DESIGN MEMORANDUM NO. 8

COOPER RIVER REDIVERSION PROJECT
LAKE MOULTRIE AND SANTEE RIVER
SOUTH CAROLINA.

RELOCATION OF
SEABOARD COAST LINE
RAILROAD BRIDGE

SUBJECT: Cooper River Rediversion Project, Lake Moultrie and Santee River, South Carolina, Design Memorandum No. 8, Relocation of Seaboard Coast Line Railroad Bridge

SCL RAILROAD BRIDGE COOPER RIVER REDIVERSION PROJECT

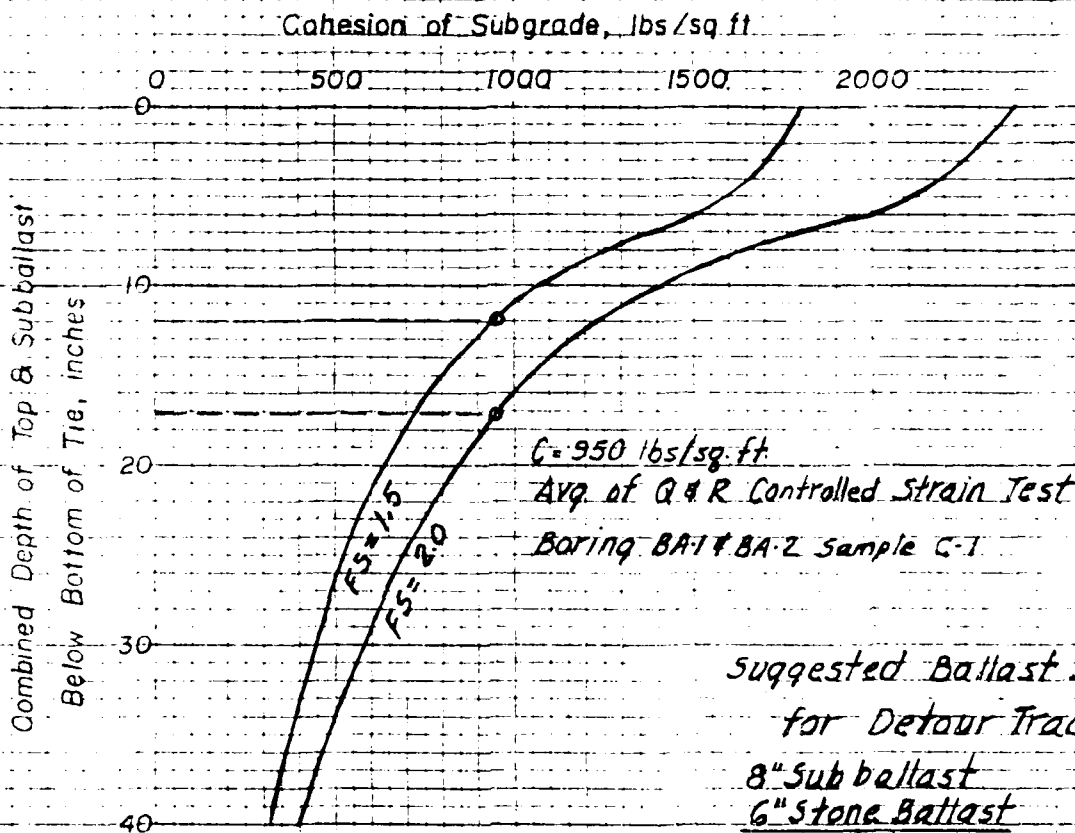
3. Paragraph 1c. The ballast section indicated for the detour track
and the rebuilt main track behind each new abutment is the current SCL
Railroad standard. The SCL Railroad has advised that they recognize
that their current standard section does not provide an adequate depth
of ballast and sub-ballast and they are in the process of revising their
standard. The final plans will provide a depth of ballast and sub-
ballast consistent with the new standard to be adopted by the SCL Railroad.
Only about 20 feet of the main track behind each new abutment will be
disturbed during construction and will require complete rebuilding of
the ballast section. The remaining work on the main track consists only
of grade adjustment which should not require roadbed design. The short
sections of roadbed embankment will be constructed with material from
the borrow pit compacted at optimum water content for maximum density.

The material is expected to average a blow count of about 30 and should
adequately support the track loads. Boring logs for the borrow area and
results of laboratory compaction tests and strength tests are shown in
Appendix No. "D". Roadbed design will be coordinated with the Railroad
during preparation of plans and specifications.

WALKWAY SECTION

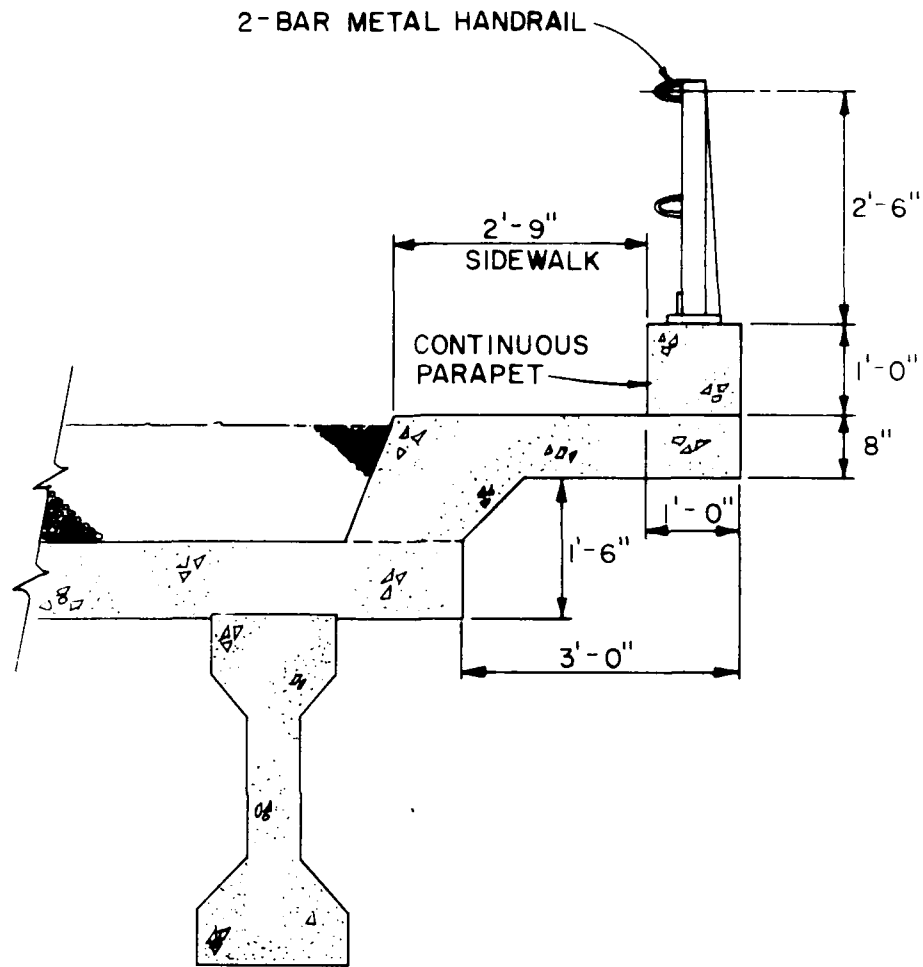
1. It is proposed that a walkway be added to the east side of the railroad bridge. A typical section is shown on the inclosed sketch. As standard procedure, the SCL Railroad has instigated the practice of constructing walkways on at least one side of all new structures and on all deck replacements of existing structures. The refuge bays currently included on the bridge would be deleted if the walkway is added.
